Preliminary Plat - Paragon Court

DEVELOPMENT REVIEW STAFF REPORT
PRELIMINARY PLAT – PARAGON COURT

PURPOSE: To approve a preliminary plat to subdivide approximately 9.3 acres into a 32 lot single-family residential subdivision with common area

ATTACHMENT 1
DEPARTMENT COMMENTS
PRELIMINARY PLAT – PARAGON COURT

PRELIMINARY PLAT OF PARAGON COURT

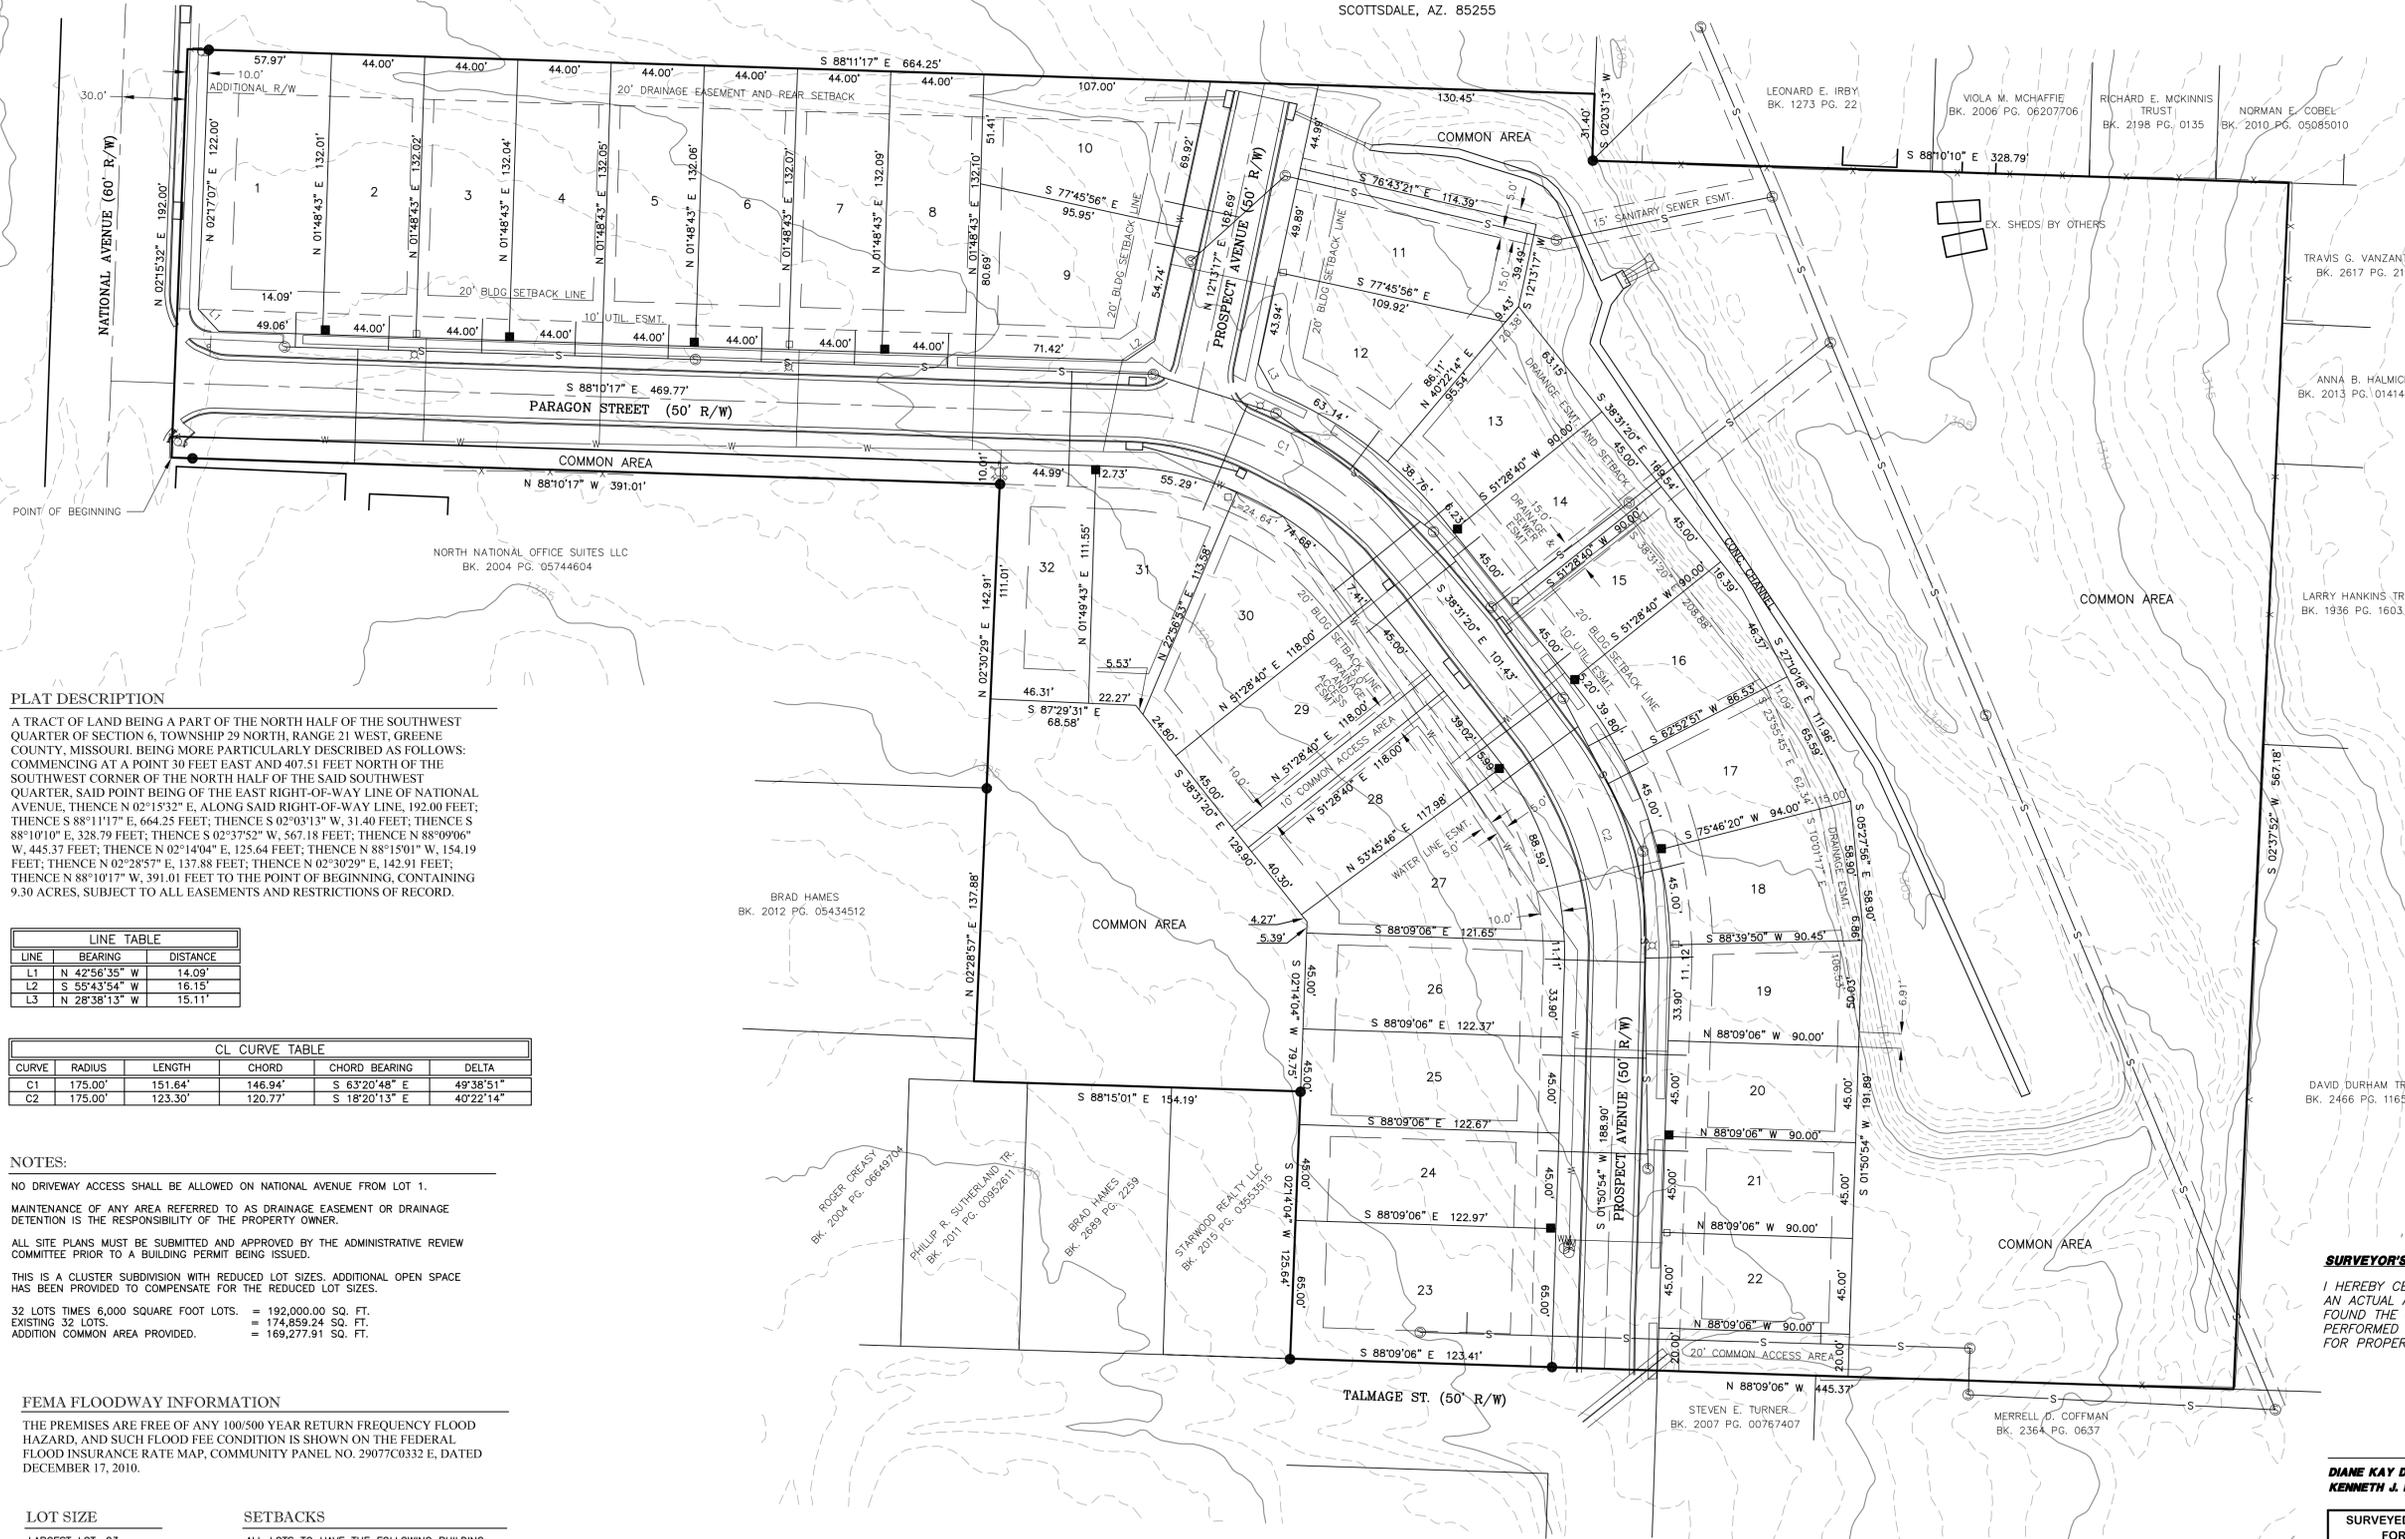
AT&T does not have facilities placed along Prospect Avenue. Please note that developer of this property will need to contact engineer Steven Beier 417-836-2761, 180 days prior to construction so facilities can be placed to serve this development. AT&T would request that the utility easement shown on the south side of Prospect Ave. read utility easement and footage.

Need to confirm water main location in lots 27-30. Our records do not show the water main encroaching this far into the lot. If it does then the water line easement makes sense. However the easement will be encroaching into the 20 foot building setback line.

5. Missing sidewalk shall be replaced.
6. Sidewalk ramp shall be added to tie sidewalk into Talmage Street.
7. Object markers shall be placed at dead-end street.
8. Storm boxes and pipes must be cleaned out and inverts poured if necessary.
9. Rip-rap pads must be added to storm inlets/exits as per original plans.
10. Also, sewer must be tested and cleanouts added as per Environmental Services comments.

1. Prospect Avenue and Paragon Street are not public streets. The streets will need to meet current City of Springfield public works standards before the city will consider them to be accepted into the city street system.
2. The size of the lots are small. Access may need to be shared by two lots (for example, Lots 1&2; Lots 3&4, Lots 5&6, etc) if the lots are developed as shown on the preliminary plat. Access must meet city code requirements specified in Chapter 98-117 - Residential Driveway Approaches.
3. No access from any lot to National.

1. Prepare and submit AS-BUILT plans on subdivision.
2. Change minimum width of sewer easements on plat and plans to 15 feet.
3. Collect Inspection Fees on unfinished or reconstructed portions of the subdivision.
4. Require the current specifications on clean outs at the ROW and visually inspected the laterals. Contractor to provide CCTV (Closed-circuit television) of laterals to inspector.
5. Environmental Services will waive the requirement for tracer wire.
6. Shoot important elevations, such as flow lines, manhole lids, etc. Show as-built pipe grades on plans.
7. Vacuum, pressure and mandrel testing need to be performed by the developer's contractor. Any defects from this testing must be corrected.
8. There are three manholes with the wrong lid and frame that need to be corrected. One lid is welded shut. Could not be inspected. One manhole has an offset frame

9. CCTV revealed 8 point repairs that need to be corrected.

- b. Sidewalks shall be constructed on one side of each internal street.
 - c. Detention basin was previously constructed but lacks sufficient volume per the approved public improvement plans. Applicant will be required to reconstruct detention basin in accordance with the approved plan or resubmit revised grading plan showing how additional volume in the detention basin will be attained.

- b. The dedication of right-of-way for National, Paragon and Prospect Avenues are required as follows. Paragon and Prospect will be classified as local residential, which requires 25 feet of right-of-way from the centerline and 50 feet of right-of-way in total. National Avenue is classified as a secondary arterial, which requires 35 feet of right-of-way from the centerline.

- c. Change minimum width of sewer easements on plat and plans to 15 feet.
3. The developer shall meet all city and state erosion control regulations prior to disturbing the soil.
